Magnolia Public Schools

Ad-Hoc (Facility) Committee Meeting

Approval of MSA-1 Owner Change Orders No. 6 and No. 7

Ad Hoc Committee Agenda Item #:	III.A.—Action Item
Date:	June 3, 2019
To:	Magnolia Educational & Research Foundation dba Magnolia Public Schools (“ MPS ”) Ad Hoc Committee (the “ Committee ”)
From:	Alfredo Rubalcava, CEO & Superintendent
Staff Lead:	Patrick Ontiveros, General Counsel & Director of Facilities
RE:	MSA-1 Change Order Requests 6 and 7

PROJECT: MAGNOLIA SCIENCE ACADEMY
PROJECT ADDRESS: 18220 SHERMAN WAY, RESEDA, CA 91335
DRAWING TITLE: ENLARGED SITE CONSTRUCTION PLAN
DRAWN BY: [Name]
DATE: 01/10/2019
JOB NUMBER: [Number]
DRAWING SCALE: AS NOTED
PREPARED BY: [Name]
DRAWING NUMBER: A0.5A

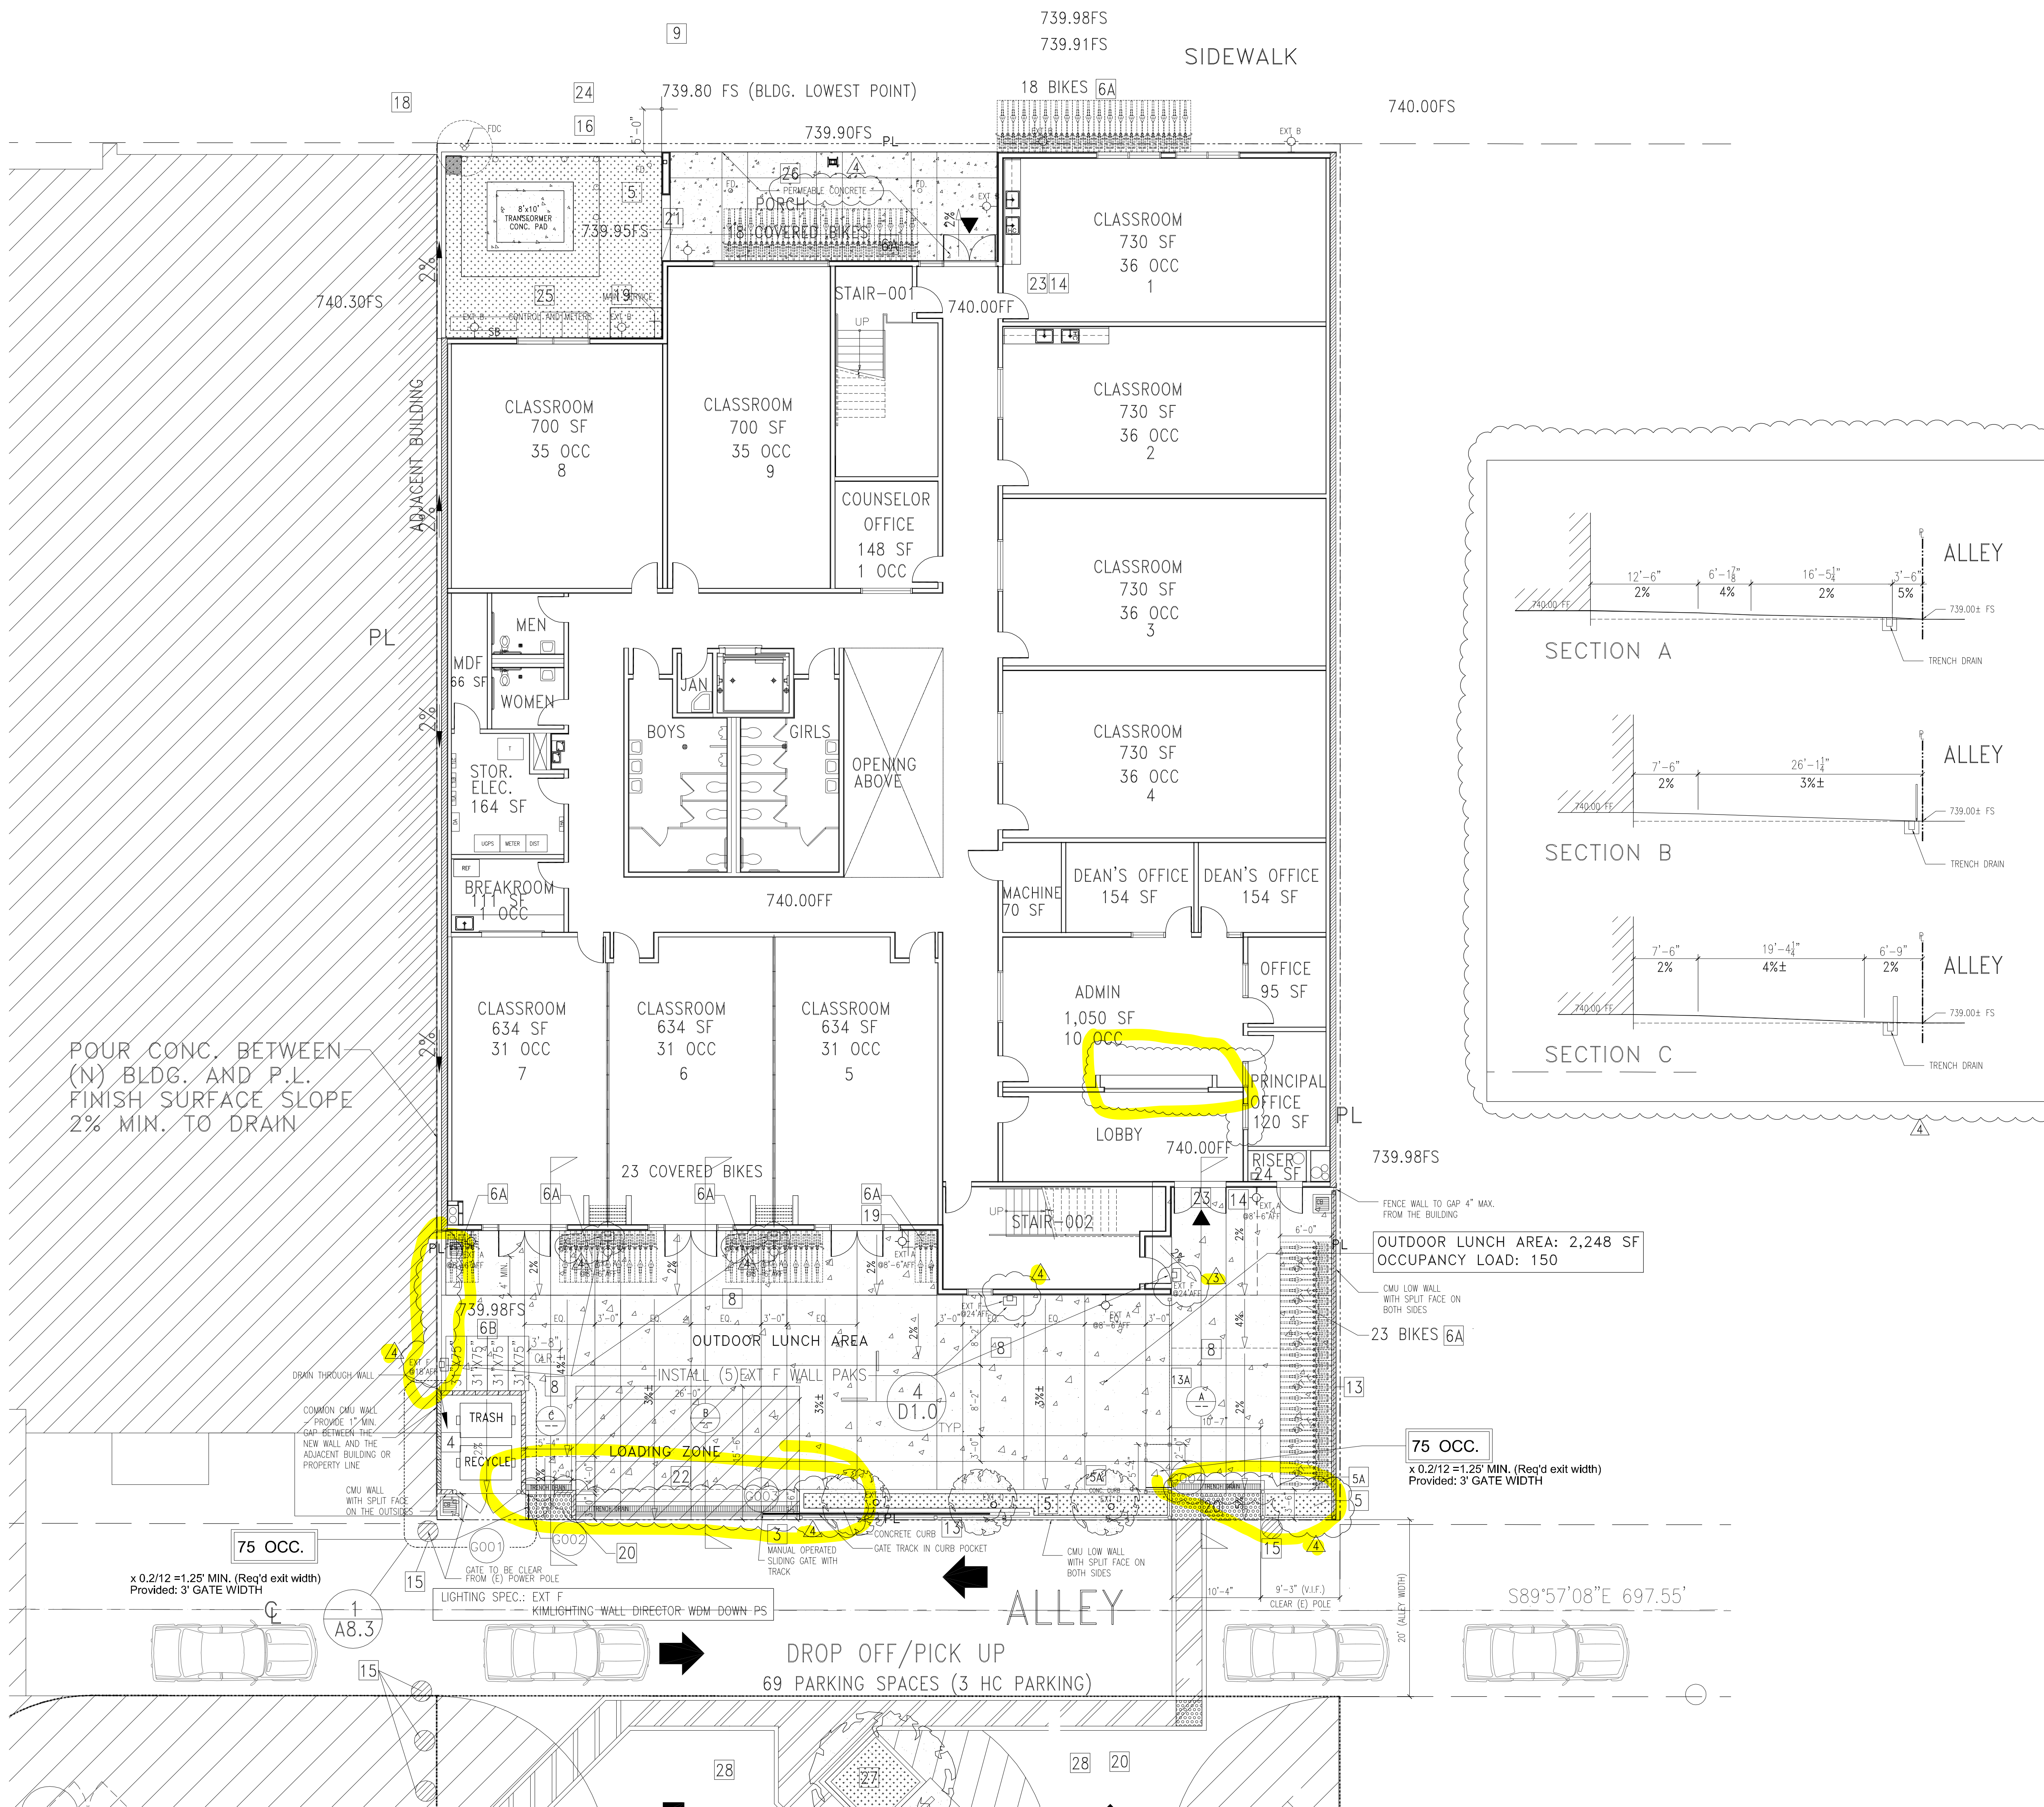
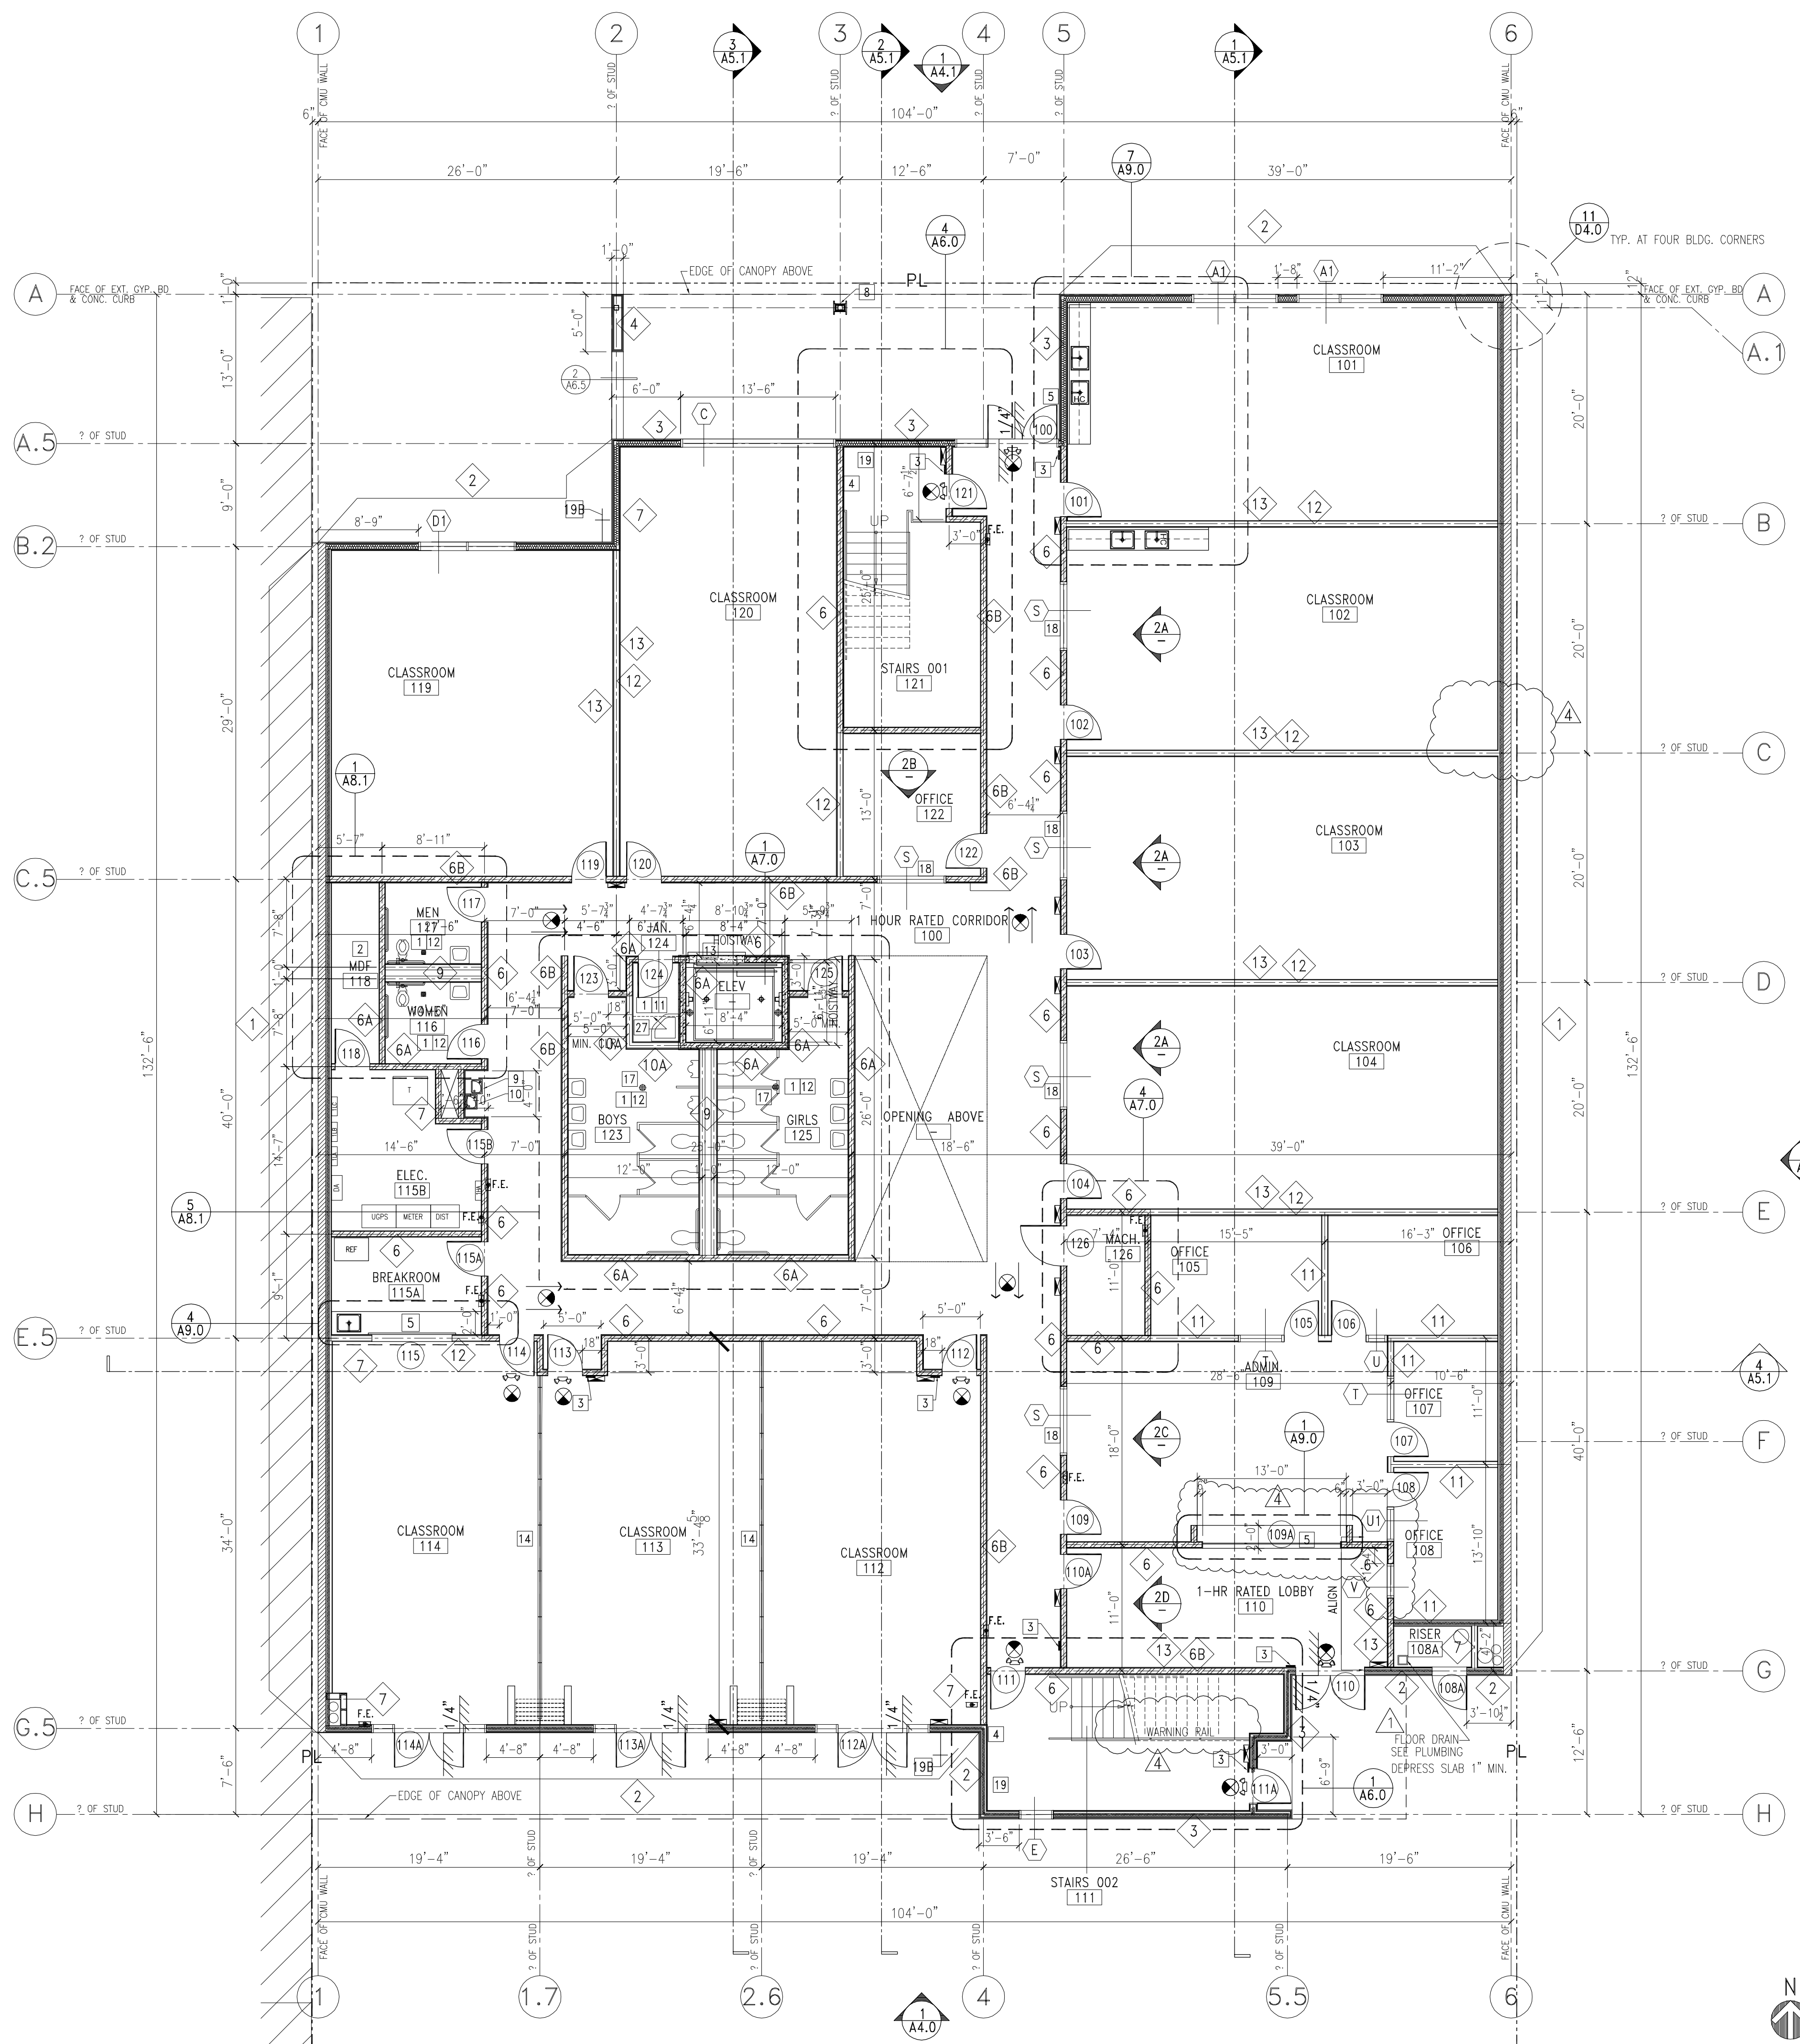
ITEM NO.	Delta No. ↓	DESCRIPTION	DET./SHEET NUMBER
1	2	Delta 1R is Bulletin 2	Coordination Bulletin 2
2	3	Delta 2 is Bulletin 3	Stand Pipe RTI
3	4	Site Plan Revision Incorporate SK-001R Incorporate SK-023 Incorporate SK-024	A0.5A
4	4	1 st Floor Plan Revision Incorporate SK-015 Incorporate SK-015R	A1.1
